RESIDENTIAL ENGINEERING SERVICES, LLC. SHOP DRAWINGS/SUBMITTAL REVIEW

2546929	Summit Homes - #13 Woodside Ridge	2021 NW Ashurst Dr.	Lee's Summit, MO	Scott Clevenger	12/1/2020
ON BOL	DESCRIPTION	JOB ADDRESS	YTIO	DESIGNER	DATE

ROOF TRUSS LAYOUT

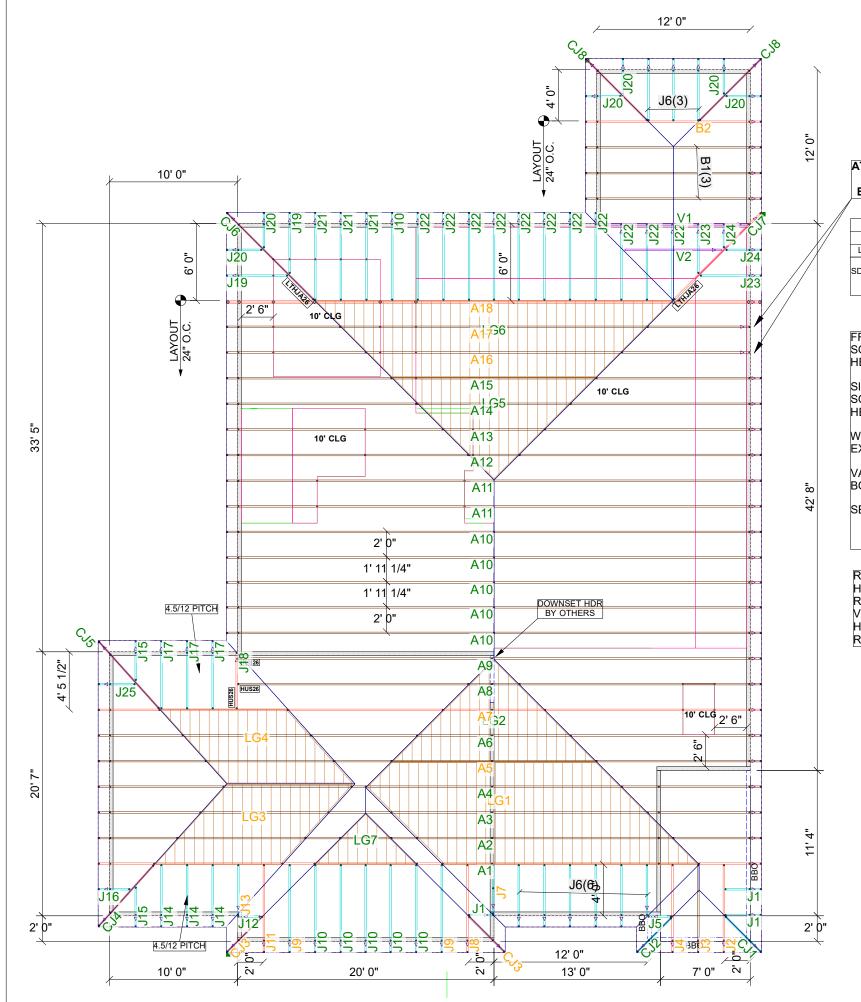
ATTACH PROVIDED 2X8 SCAB PER **ENG DWG NOTES**

APPROVED
